**CITY OF LA VISTA**  
**MAYOR AND CITY COUNCIL REPORT**  
**MARCH 16, 2021 AGENDA**

<b>Subject:</b>	<b>Type:</b>	<b>Submitted By:</b>
PLANNED UNIT DEVELOPMENT SITE PLAN AMENDMENT – LOTS 1 & 16 HARRISON HILLS	RESOLUTION ◆ ORDINANCE RECEIVE/FILE	CHRISTOPHER SOLBERG DEPUTY COMMUNITY DEVELOPMENT DIRECTOR

RE: Planned Unit Development Amendment – Initial Review Letter  
Lot 1 Harrison Hills

Reference: Streck, Inc. – Harrison Hills  
Planned Unit Development Amendment Submittal Comments  
Project No.: 0118087.06-003

**PLANNED UNIT DEVELOPMENT SITE EXHIBIT**

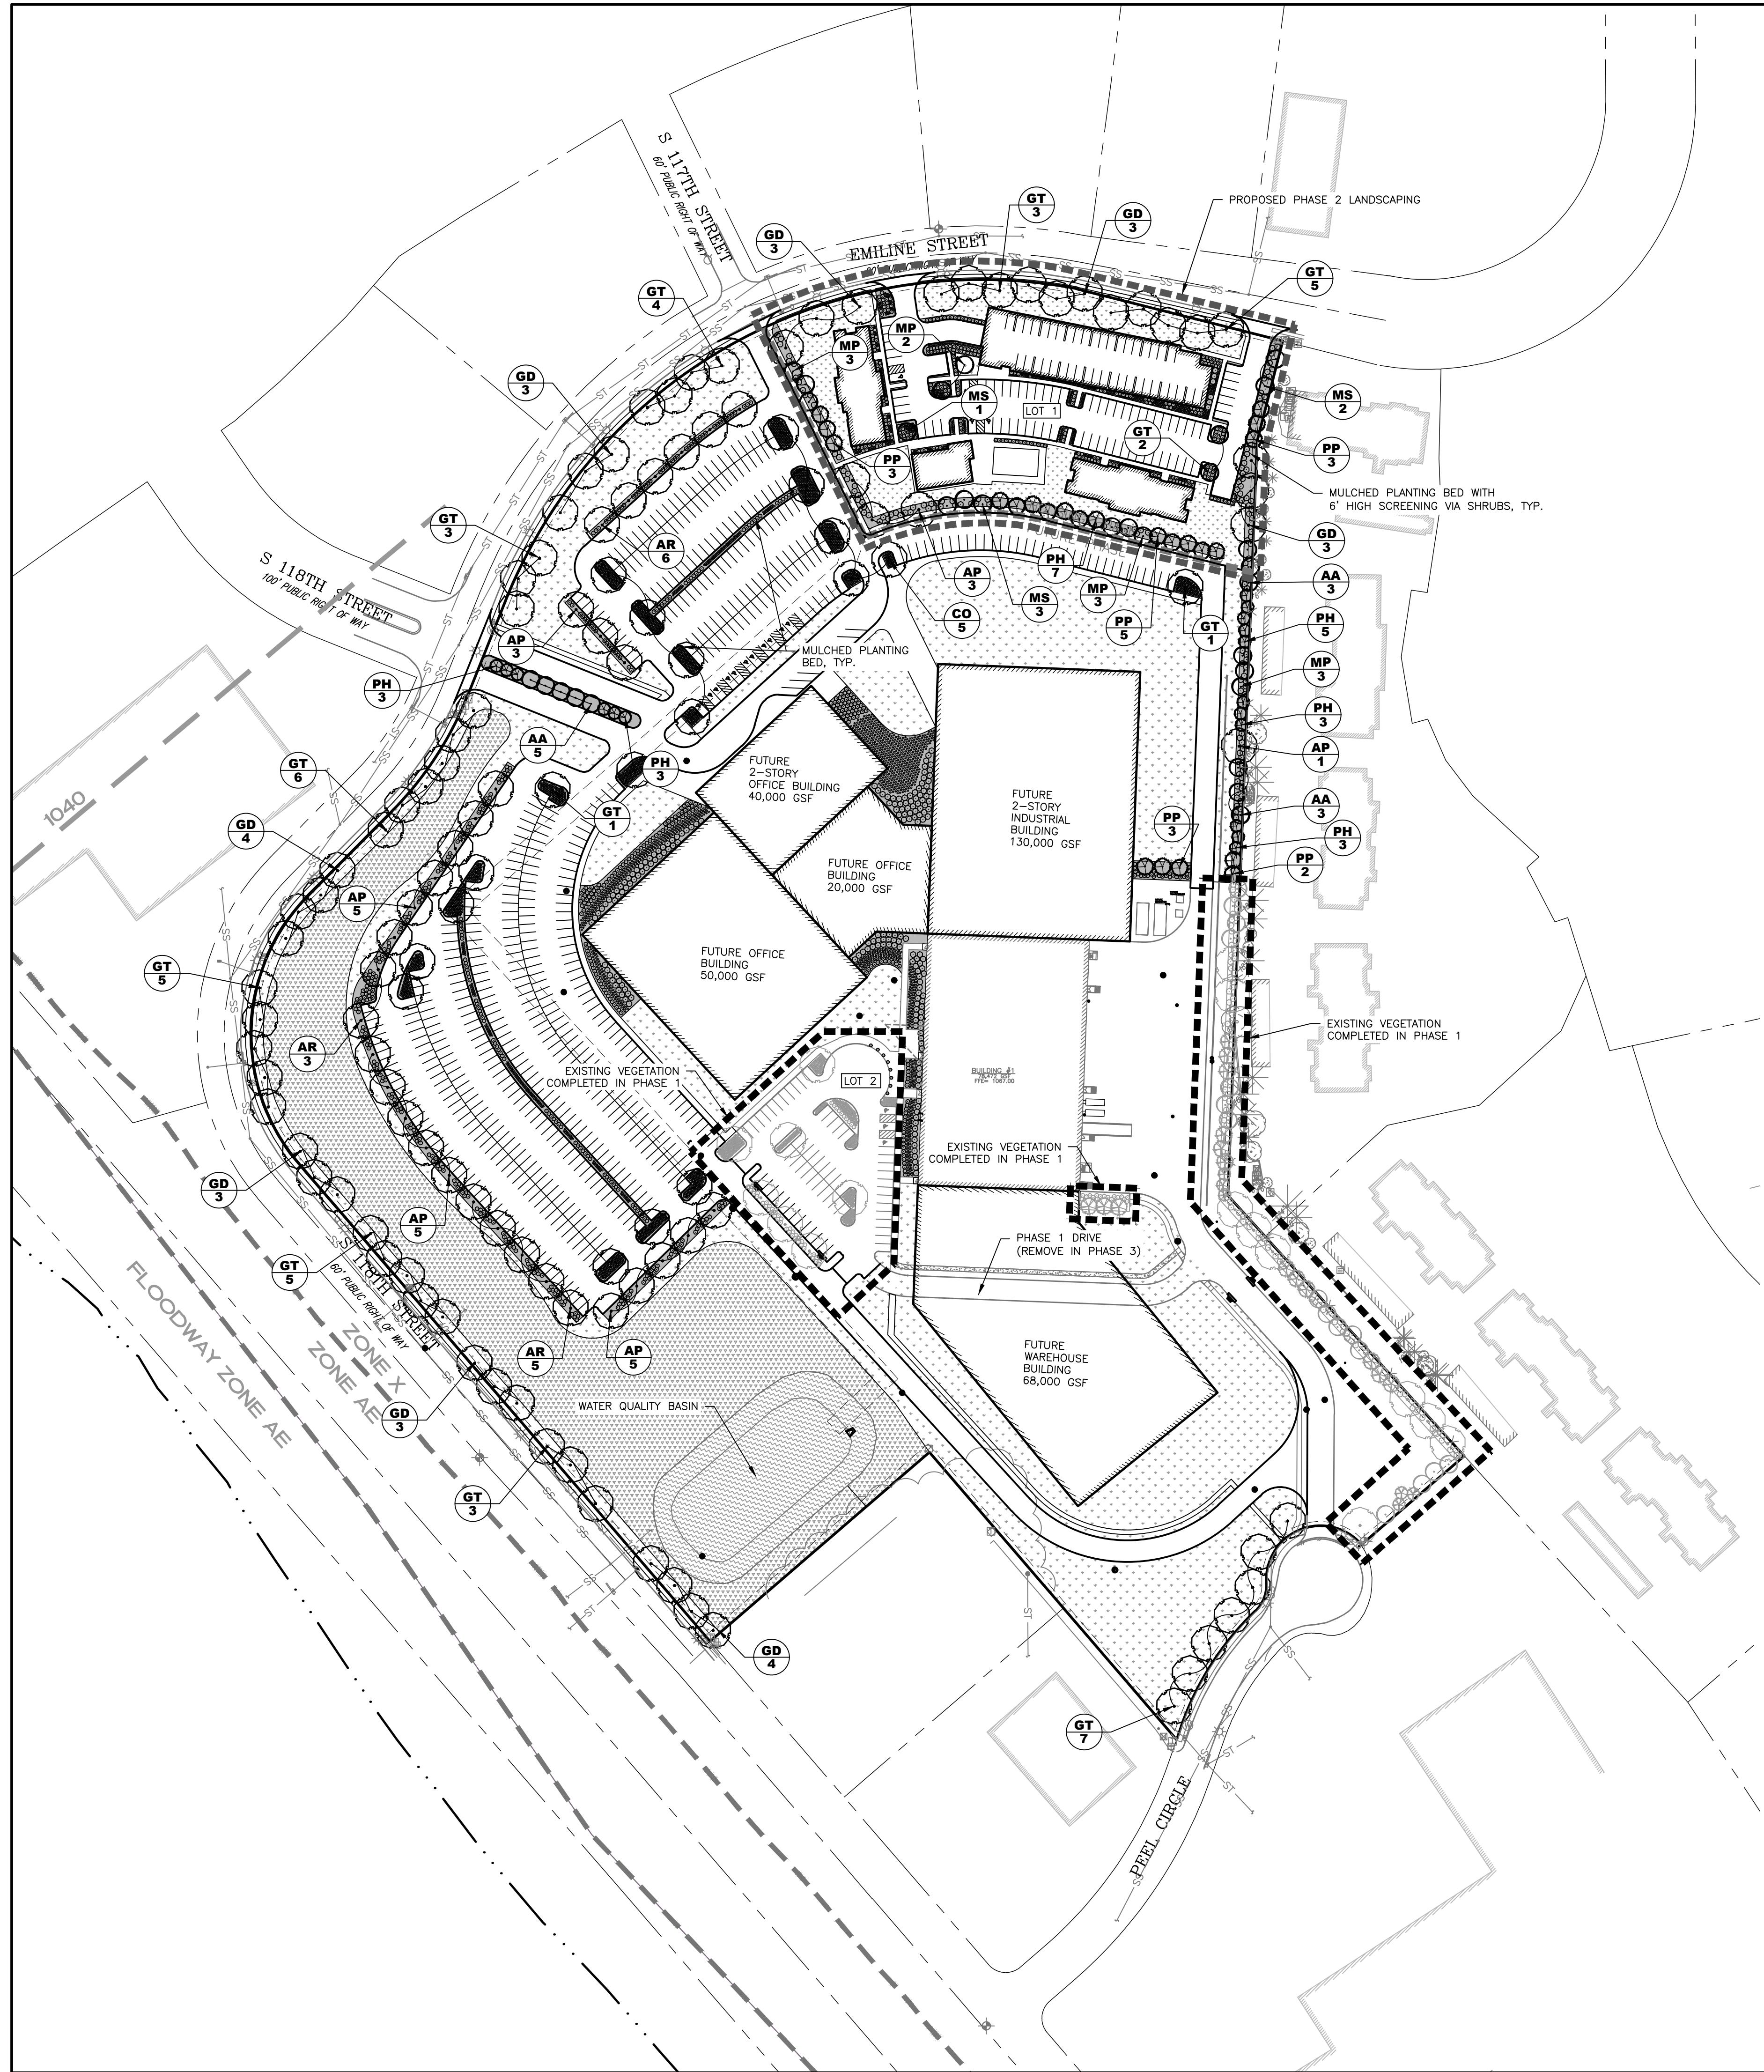
1. Section 5.15.03 – The zoning listed on the PUD Site Plan needs to be corrected to include the correct spelling of the Gateway Corridor District (Overlay District).
2. Section 5.15.04.01 – Please submit a schedule for construction consistent with the requirements of this section. The phasing exhibit should clearly show the existing infrastructure and buildings as well as show the proposed phasing.

The layout of the existing west parking lot should be modified to depict the proposed layout at buildout, not the existing as approved through the original PUD Site Plan. Hence the parking stalls should be removed from the two entrance points, the gap in the curb line at the south end closed up, and the overall parking stall count adjusted accordingly.

9. Section 5.15.04.10 – A table, drawing and/or calculation of net developable area needs to be included to ensure this requirement for maximum building coverage is met.

10. Section 5.15.04.11 – A table, drawing and/or calculation of net developable area needs to be included to ensure this requirement for common open space is met.

21. Section 5.15.05.02, Subsection 2 - Height of each proposed structure needs to be addressed within the PUD plan.

**Response:** This has been completed as requested.

**Response:** This has been completed as requested.

**Response:** This has been completed as requested.

**Response:** This has been completed as requested.

**Response:** Building heights will follow the base zoning districts maximum allowable height. This has been noted in the site regulator table.

PLANTING PLAN

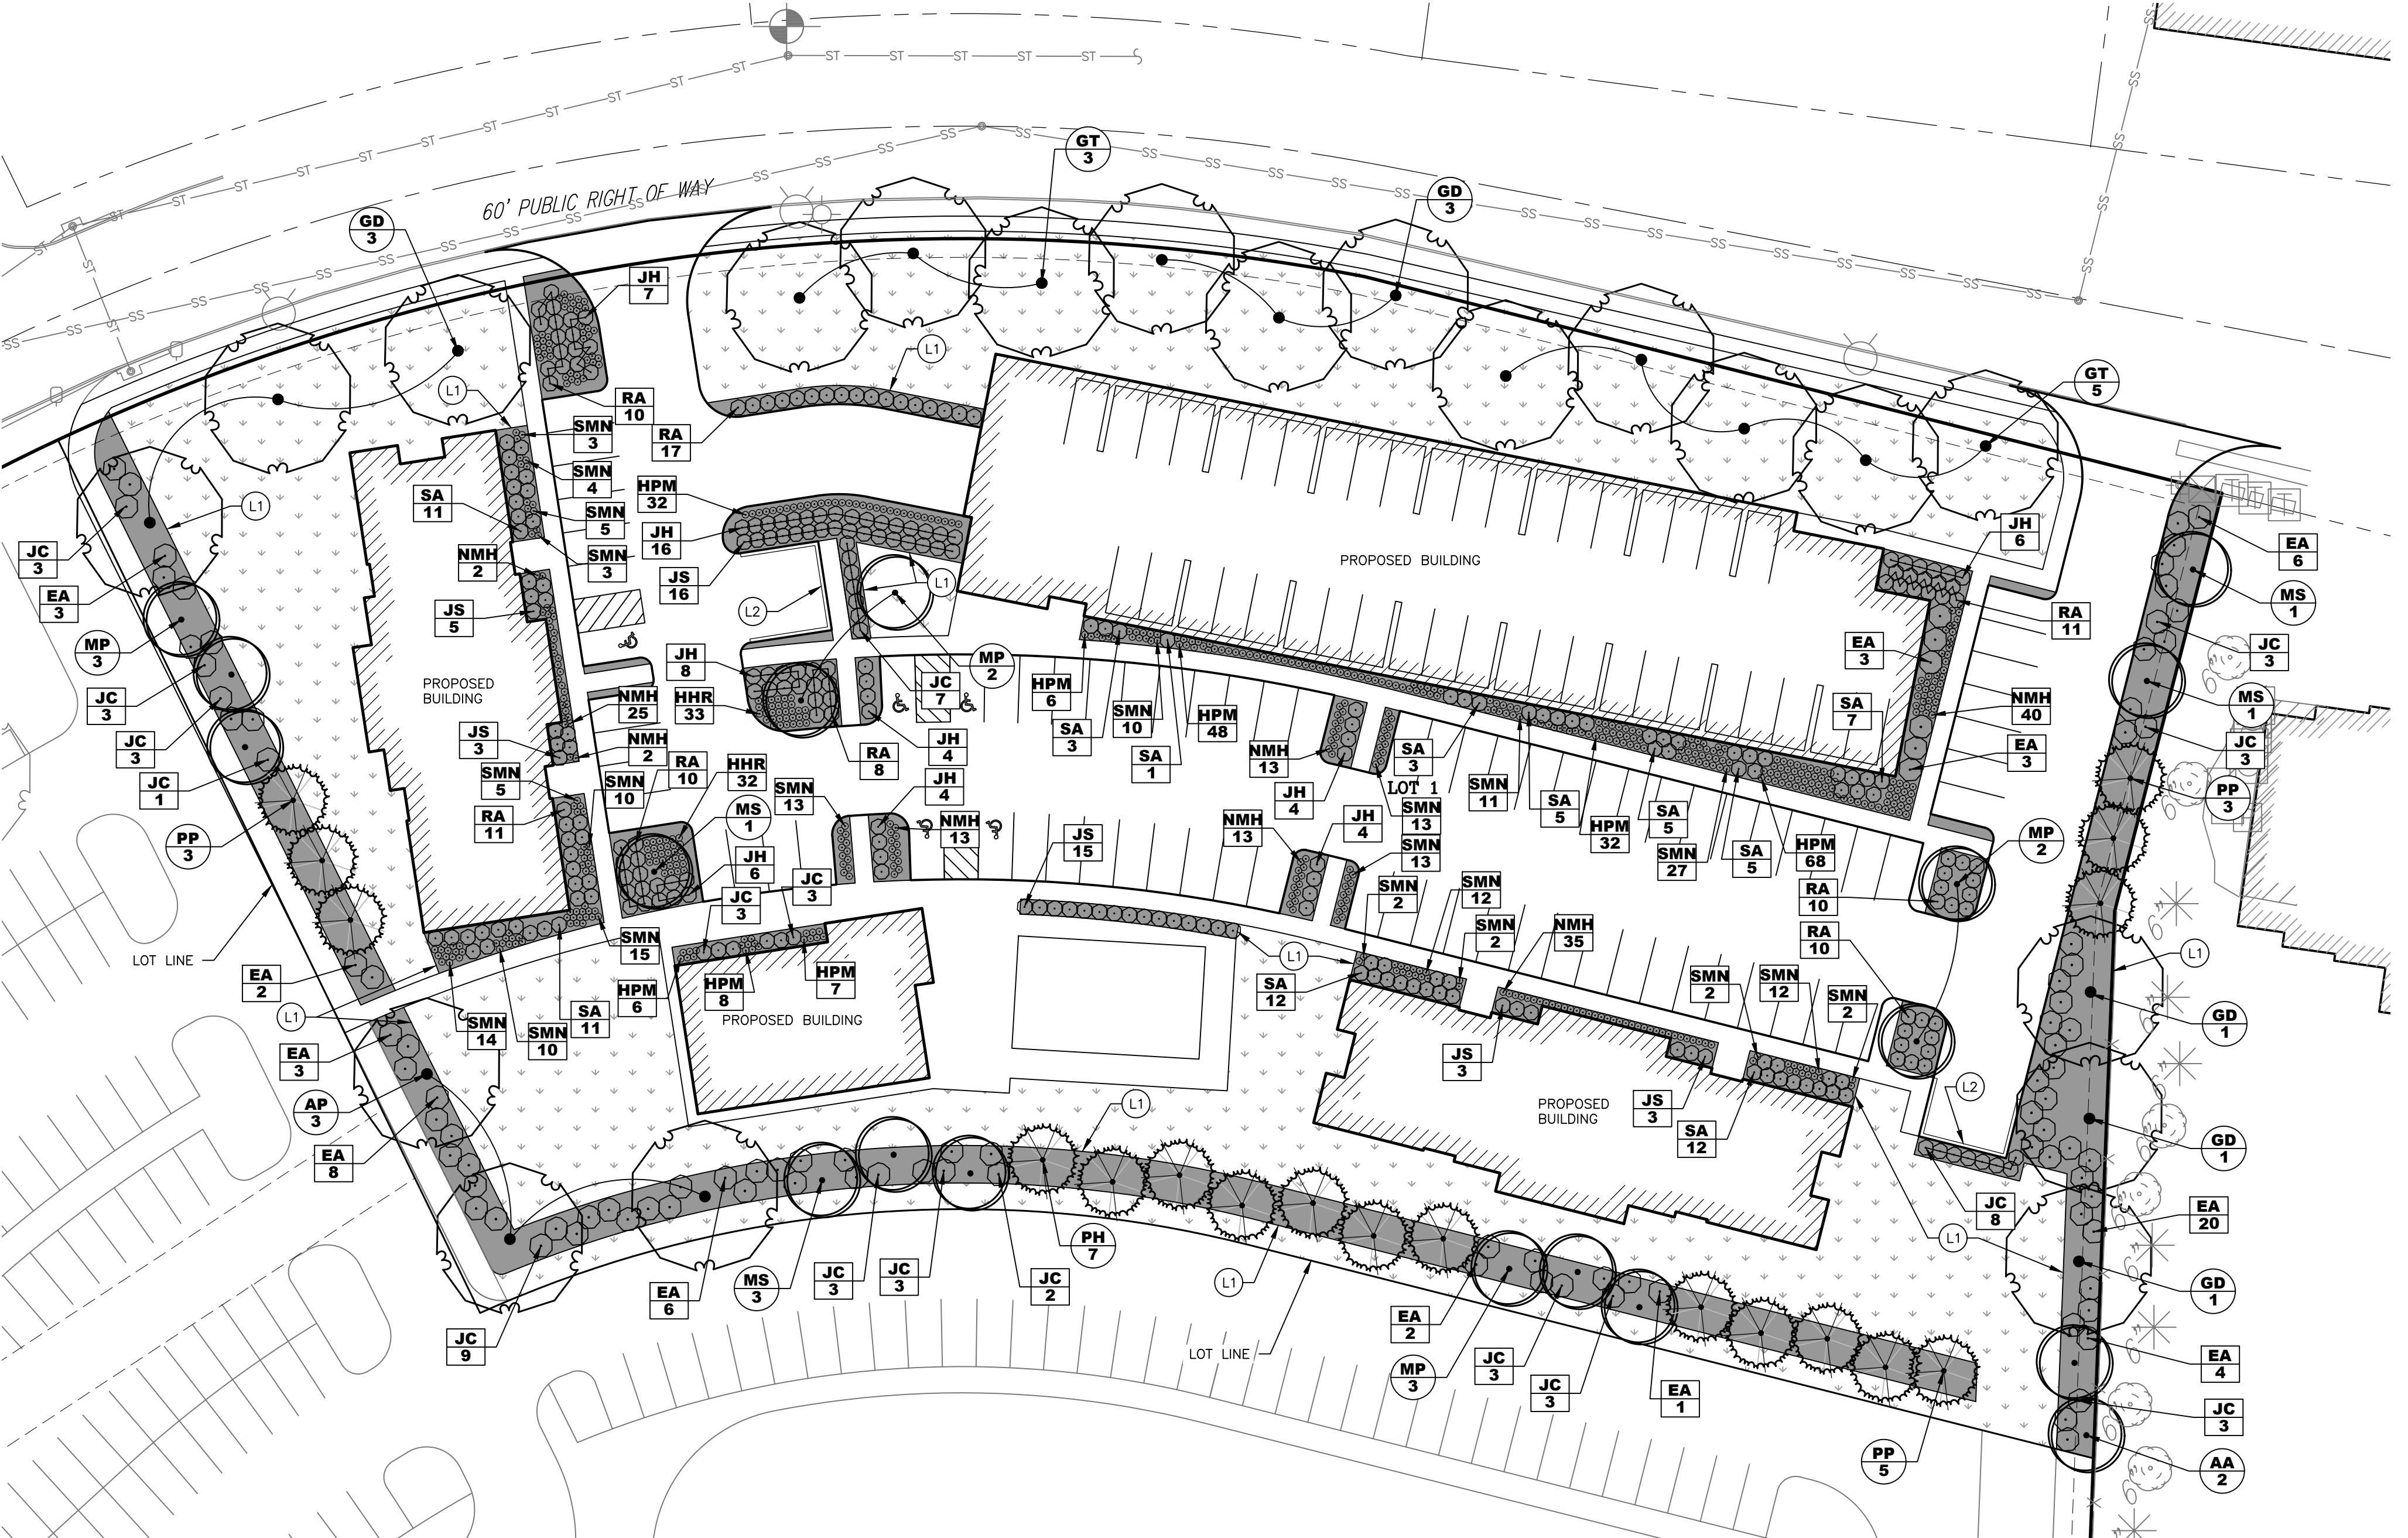
- a. Landscape shall be designed to provide natural undulating landscape forms. Avoid consistent straight-line plantings. See Section 4, III, F. Plantings around the west driveway off Emilie St and between the parking and buildings are shown in straight lines. Consider undulating forms and massings.

b. Screening of service yards, mechanical, electrical, phone equipment and pedestals and other places that tend to be unsightly is required and may be accomplished with plantings. See Section 4, III, I. Please indicate if screening of trash enclosures is to be included in landscape review.

**Response:** Landscaping has been revised to implement undulating forms and massings as requested.

**Response:** Trash enclosures will be screened by means of architectural masonry wall/gate and shrubs/trees.
